CALVERT CLIFFS NUCLEAR POWER PLANT

SUBJECT: Calvert Cliffs Nuclear Power Plant
Independent Spent Fuel Storage Installation
Material License No. SNM-2505, Docket No. 72-8
Responses to Request for Additional Information, RE: Calvert Cliffs Independent
Spent Fuel Storage Installation License Renewal Application

**CALVERT CLIFFS RESPONSE TO NRC REQUEST FOR ADDITIONAL
INFORMATION**

CALVERT CLIFFS NUCLEAR POWER PLANT, LLC
SPECIAL NUCLEAR MATERIALS LICENSE NO. 2505
DOCKET NO. 72-8
LICENSE RENEWAL REQUEST
FIRST REQUEST FOR ADDITIONAL INFORMATION

Figure 1

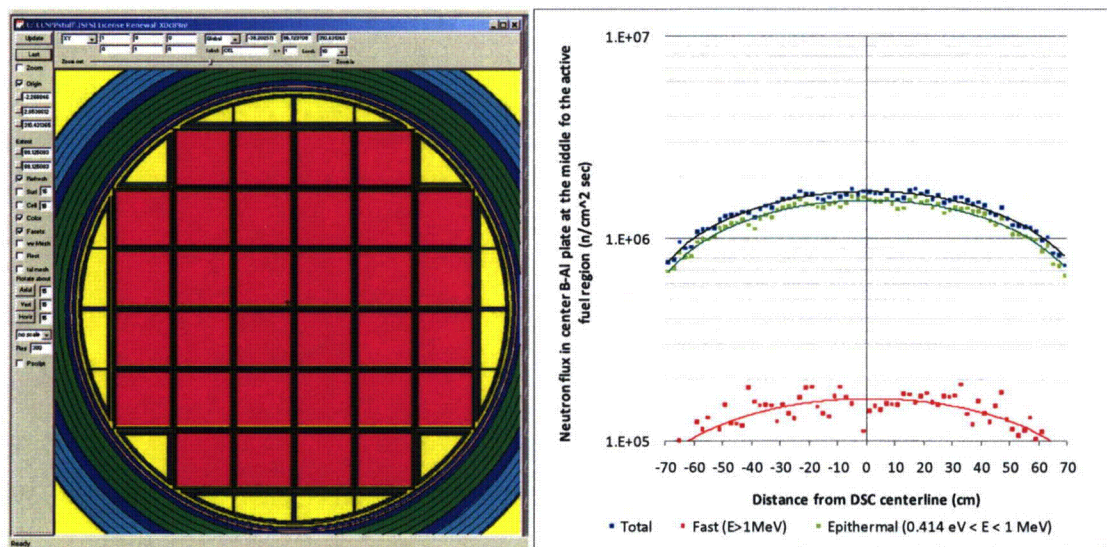
Provide a description of the expression and assumptions used in Appendix 8, ISFSI Time-Limited Aging Analysis Report, Section 4.1 for the calculation of the estimated total scalar neutron flux and the technical basis for the selection of parameter values used in the calculation.

In the Appendix 8, ISFSI Time-Limited Aging Analysis Report, Section 4.1, ISFSI Materials and Analyses Review of Poison Plates for the NUHOMS-32P, an approximation is used to estimate the total scalar neutron flux based upon a calculated scalar neutron flux. The applicant is requested to provide a description of the expression and assumptions used in the calculation of the estimated total scalar flux as well as a technical basis for the selection of parameter values used in the calculation.

The method utilized in Reference 1, Appendix B, Section 4.1, simply divided the design basis assembly neutron source for a NUHOMS-32P DSC by the inner surface area of a NUHOMS-32P DSC fuel cell. The use of the word scalar refers to the fact that neutron direction is ignored in this estimate and all source neutrons are assumed to pass through the fuel cell wall (i.e., axial leakage is ignored). To provide a second check of the approximation used in Reference 1, Appendix B, Section 4.1, Calvert Cliffs performed an independent check for this response using an in-house MCNP5 model of a NUHOMS-32P DSC containing the design basis neutron source from Calvert Cliffs Calculation CA06721, Section 6.5 (see ADAMS Accession Number ML091680542). The MCNP5 model was based on the transfer cask model used in Calvert Cliffs Calculation CA06750 (see ADAMS Accession Number ML091680544), modified to include an explicit model of the basket with homogenized fuel. A neutron flux mesh tally over the center poison plate was utilized to calculate the flux over the entire length of the poison plate. The results at the centerline of the active fuel region suggest that the method utilized in Reference 1, Appendix B may not reflect the peak neutron flux, which is calculated to be $1.69\text{E}6 \text{ n/cm}^2\text{s}$ at the center of the plate using MCNP5 model (as shown in Figure 1 below). The energy distribution of the flux is 93% epithermal ($0.414 \text{ eV} < E < 1 \text{ MeV}$) and 7% fast ($E > 1 \text{ MeV}$), with the thermal flux being negligible. This increases the 60 year fluence to $3.20\text{E}15 \text{ n/cm}^2$ using the same assumptions as in Reference 1, Appendix B, Section 4.1 (no decay in design basis source over 60 years). Note, however, that this does not alter the Section 4.1 conclusion that the 60 year fluence has a negligible impact on boron content of the plates, since 99.9993% of the boron would remain after 60 years even if every neutron was assumed to be absorbed by B-10. If actual B-10 reaction rates were considered based on the energy distribution of the flux, the depletion would be expected to be several orders of magnitude less.
